## ITEM 6: 202004060016 – Mojo on Broadway (Certificate of Appropriateness – HPA New Construction)

A Certificate of Appropriateness to construct a parking lot and a sidewalk, and demolish a deck, gazebo and shed.

The applicant is requesting approval of a Certificate of Appropriateness (COA) to construct a parking lot and sidewalk, as well as demolish the deck, gazebo and shed, in the rear of the property, located in the Historical Preservation Area (HPA), to operate a t-shirt/apparel retail business, Mojo on Broadway.

Proposed Parking Lot Plan

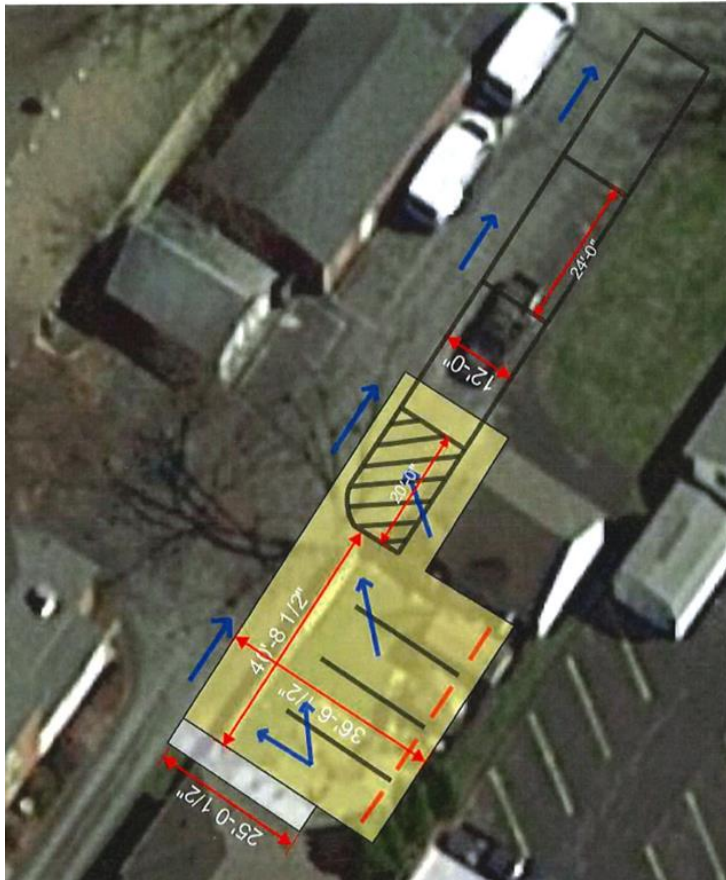
The parking lot is proposed behind/to the east of the property's main building. A five-foot sidewalk is proposed between the building and parking lot to provide pedestrian access into the building. The existing rear deck, gazebo and shed will be removed to provide space for the parking lot. Staff is supportive of the demolition of these structures as they will need to be removed to provide enough space for the parking lot and allow the property to have a more commercial appearance. The parking lot is proposed to have seven parking spaces. Four of the parking spaces will be located between the building and the garage and will be 180 square feet in size (10' by 18'). There is a discrepancy in the plan which states the spaces are 10' by 20', which will need to be updated to match the project's response letter. Three of the parking spaces will be located behind/to the east of the garage and will be parallel spaces at 288 square feet in size (12' by 24'). While staff is supportive of parallel spaces being integrated into the site, staff believes that these should be narrowed to ensure they do not encroach on any shared drive. Other projects in the City have contained parallel spaces at eight feet in width. Based on the size of the building, a minimum of eight parking spaces are required, and seven are proposed. Staff believes that the additional parking space should be added for the property to comply with the required amount.

The four spaces proposed between the building and garage will be setback four feet from the south property line to be lined up with the building, as well as an existing fence, and allow vehicles more room to access the spaces. Code requires that the spaces be located 10 feet from the property line; however, staff is supportive of the deviation to provide additional space on the property for vehicles to access. Many of the other nearby commercial properties, including the properties to the north and south, are deviating from the setback requirement to accommodate their parking lots as well.

The parking lot is proposed to be accessed from a driveway that runs to the north of the building and is partially located on the applicant's property and partially on the property to the north (4086 Broadway). This drive runs from Broadway to the west to First Street to the east. The property to the north, 4086 Broadway, has been using this drive, but the site (4094 Broadway) has been using its own driveway from First Street. No shared access agreement has been created between the properties; however, the applicant has indicated that the property owner for 4086 Broadway is agreeable to creating the agreement. This agreement will need to be formalized and recorded with Franklin County to properly document the legal terms each party agrees to, including access and maintenance. The driveway is approximately 10 feet in width and staff recommends it be included in the agreement that the drive be one-way access to prevent any issues with vehicles on the site.

The applicant is proposing to install some landscaping along the parking lot's perimeter but has not indicated what type of plantings will be installed. Per Code requirements, one tree and two shrubs are required per 40 lineal feet of the property line adjacent to the parking lot. The applicant has been working with the Urban Forester to determine the best locations and planting types will be the most appropriate and healthy on the property and has indicated he that will continue to work with the Urban Forester.

1. A deviation shall be granted from Section 1136.06(b) to permit a side parking lot setback of four feet from the south property line.
2. The plans shall be updated to show the correct proposed parking space sizes.
3. The parallel spaces shall not encroach into the shared access drive.
4. One additional parking space shall be provided on the property to bring the total parking on the site to eight (8) spaces.
5. A shared access agreement shall be recorded by the property owners of 4086 and 4094 Broadway to utilize the driveway between both properties.
6. The applicant shall work with the Urban Forester to locate and find the most appropriate trees, shrubs and other plantings for the parking lot.
